FISH PASSAGE CENTER

MEMORANDUM

RE: Review 2011 Acoustic Tag study design for John Day Dam

Figure 1. Modified from Figure 2 (Anon. 2011). Schematic of the Virtual-Paired Release model for a single dam. Shaded areas of potential handling/tagging effect added by Fish Passage Center.

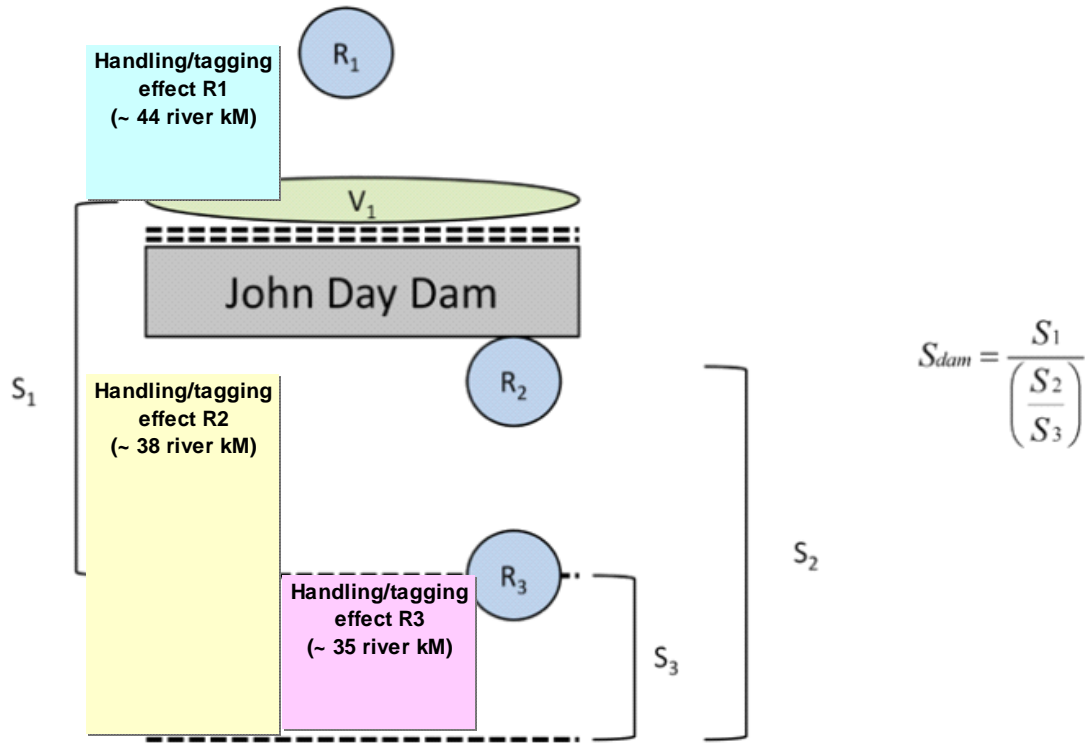
These two assumptions are: (i) the handling/tagging effects for release R_1 is expected to be zero by the time these fish are re-counted as virtual release 1 (V_1); (ii) the handling/tagging effects on R_2 and R_3 are expected to be equal and cancel out in the calculation of dam survival (S_{dam}).

The handling/tagging effects on R_2 may be more than those of R_3 for two reasons. First, the approximate river kilometers where handling/tagging effects could be expressed are greater for R_2 than R_3 . The amount of handling/tagging bias, and duration over which it is expressed is unknown. However, since the unadjusted survival of R_2 is measured over a longer reach than for R_3 , this could bias the survival for R_2 low. Second, there is no accounting for any interaction between tagging/handling effect and where the release takes place. One working hypothesis could be that handling/tagging effects have a more negative effect on the subsequent survival in an area that ostensibly contains high predator numbers (e.g. tailrace of a dam) than for downstream releases. Both of the above potential negative biases of S_2 would cause the measurement of S_{dam} to be biased high. This relationship can be shown with a simplification of the equation shown in Figure 1:

$$\uparrow S_{dam} = \frac{S_1 * S_3}{\downarrow S_2}$$
